Iowa Department of Transportation
Highway Division

STANDARD DESIGN - 44' ROADWAY, THREE SPAN BRIDGE

PRETENSIONED PRESTRESSED CONCRETE BEAM BRIDGES

H44-08-07

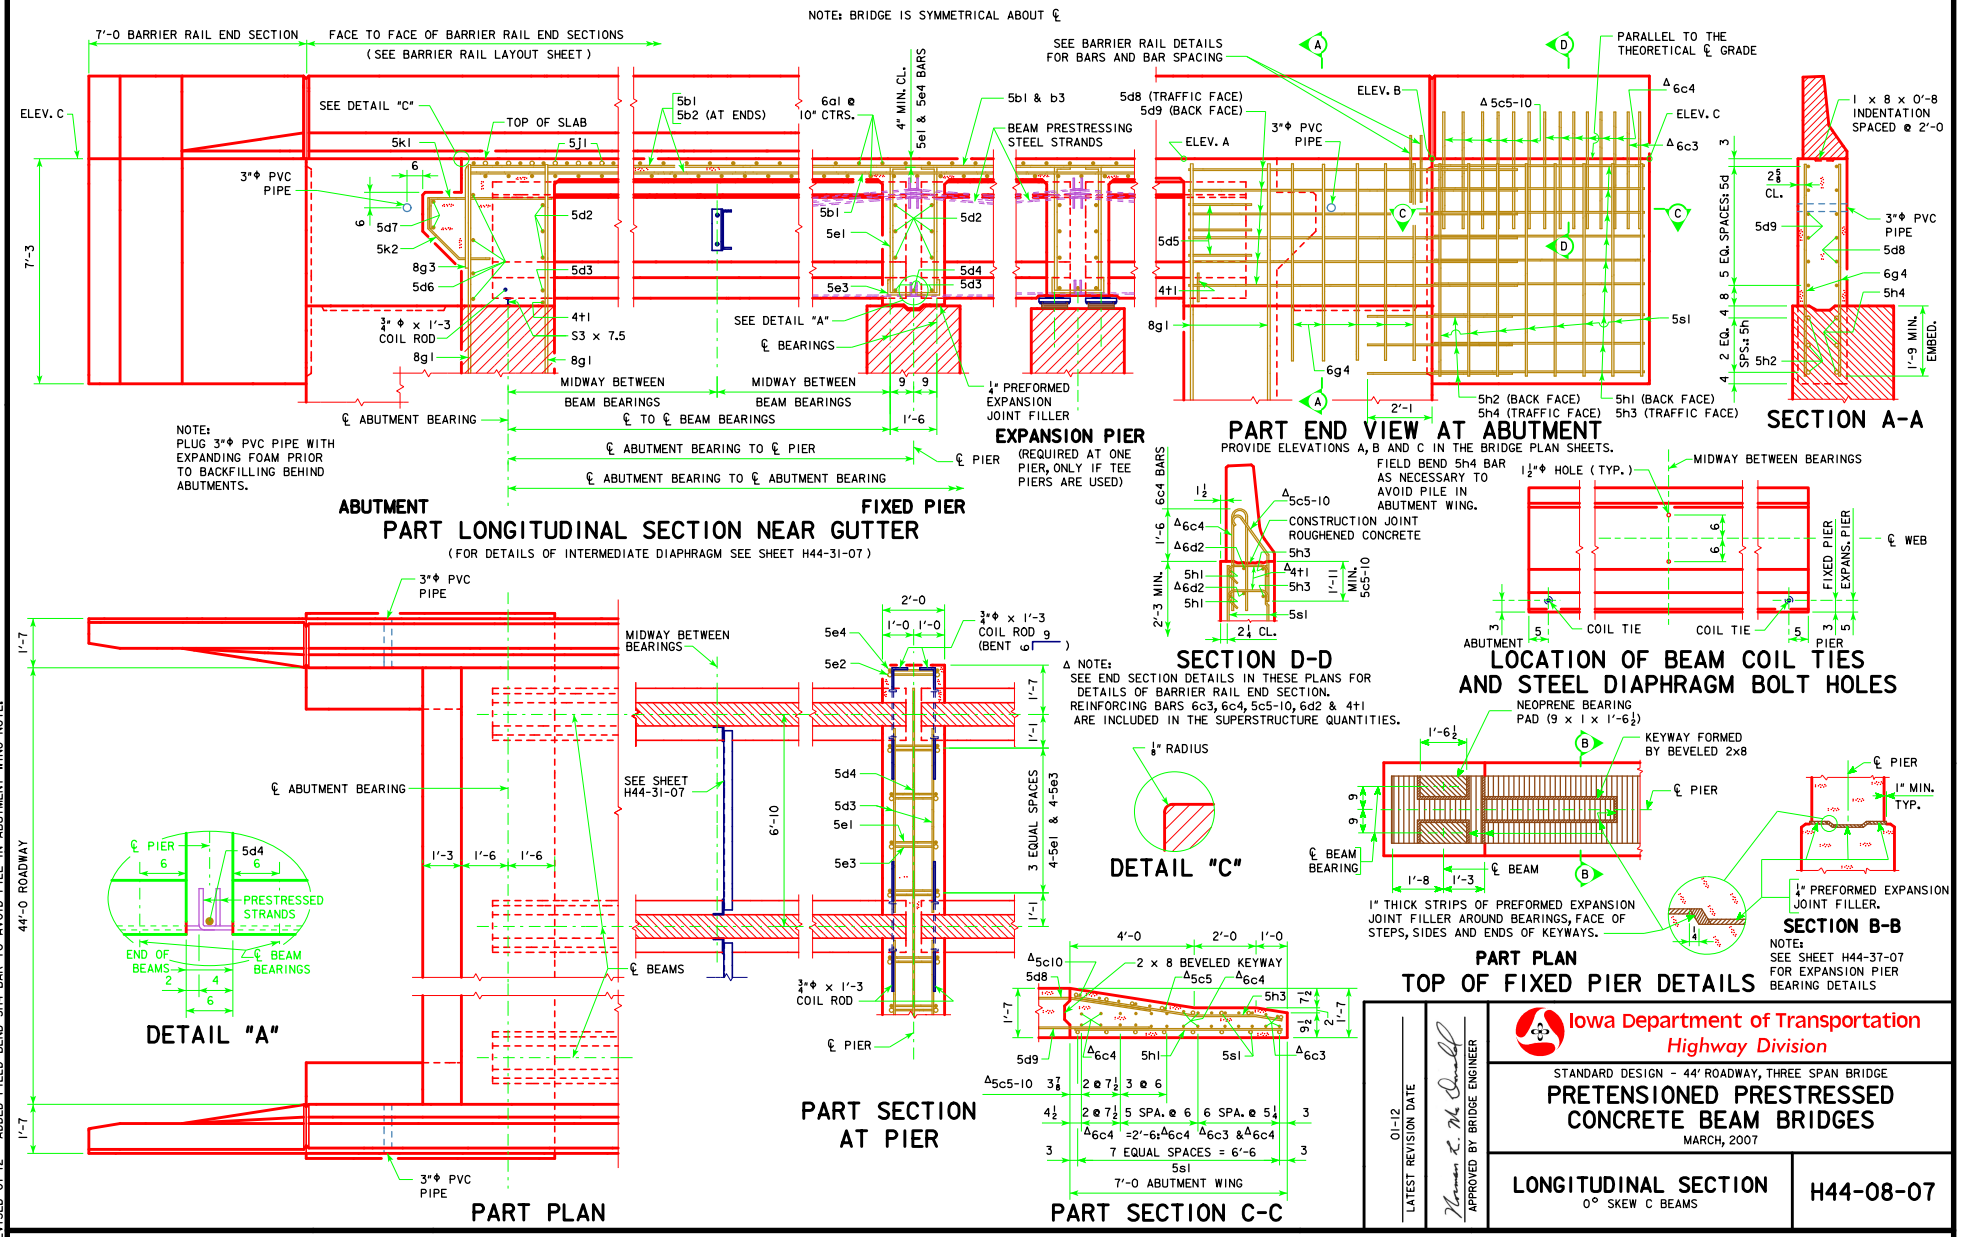
REVISED 01-12 - ADDED FIELD BEND 5h4 BAR TO AVOID PILE IN ABUTMENT WING NOTE.
